E4418B-21A

S E R V I C E   N O T E

EPM Power Meter

Compatibility between front panel assembly and processor assembly.

Processor Assembly

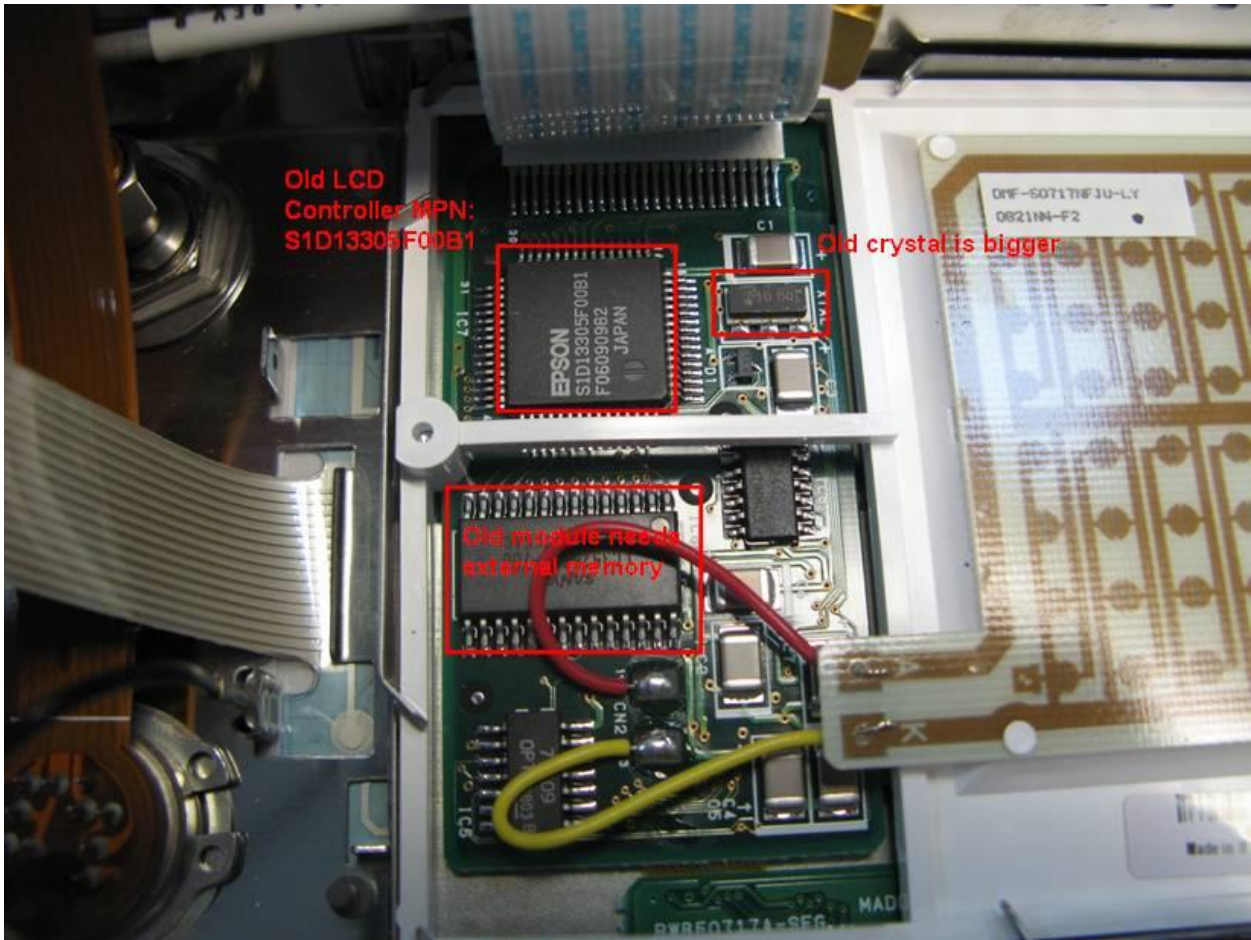
The new processor assembly can be differentiated through U7 and U8 on the assembly.

1. Zoom to location U7 and U8 of the processor assembly.

2. Verify that the 5X5 part number on the flash IC is E4418-80028 and E4418-80029 for U7 and U8 respectively. The old 5X5 part number is E4418-80019 and E4418-80020 for U7 and U8 respectively.

Front Panel Assembly (for standard option, option 002 and option 003)
The new front panel assembly can be differentiated through some components as illustrated below.

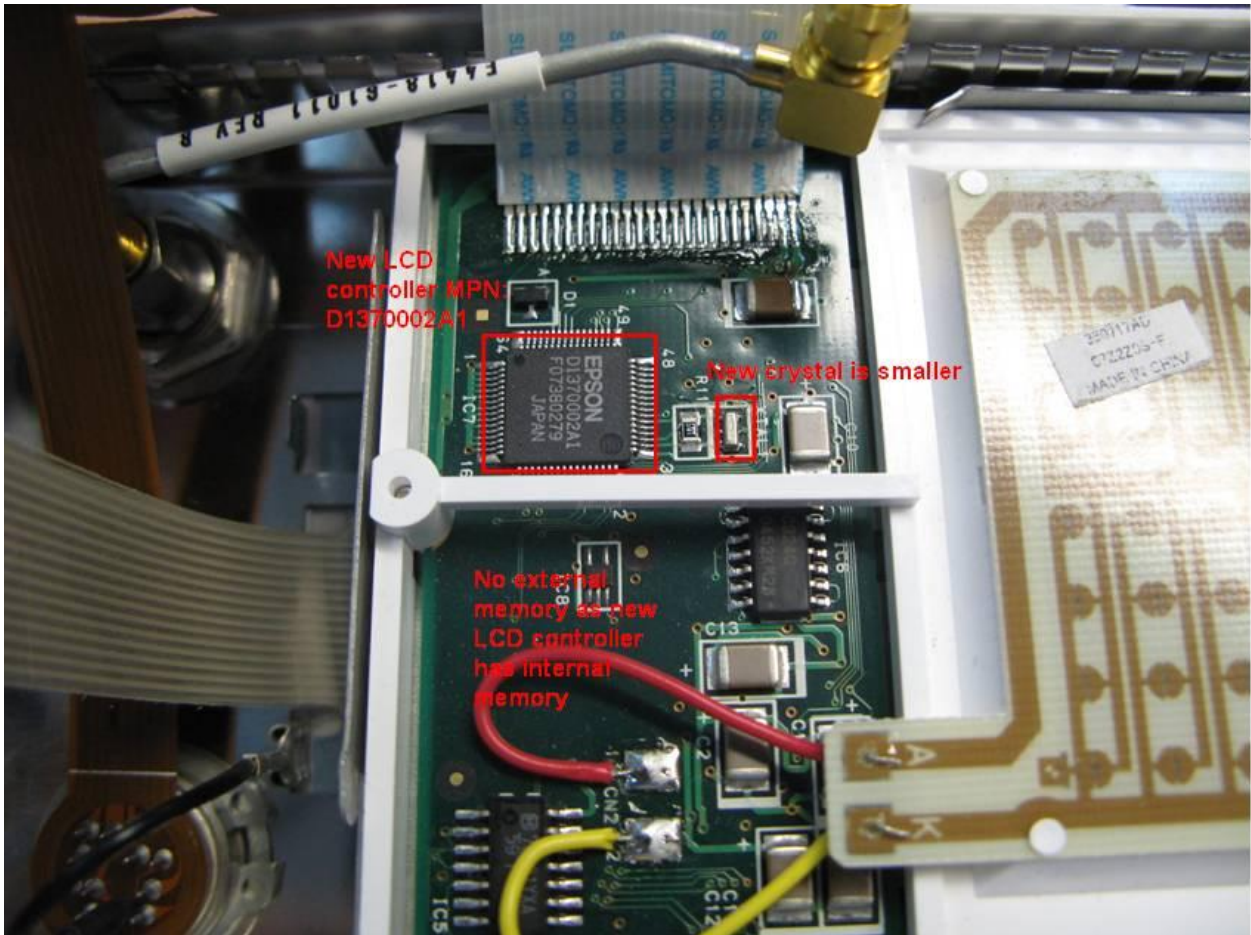
Old Front Panel Assembly

New Front Panel Assembly
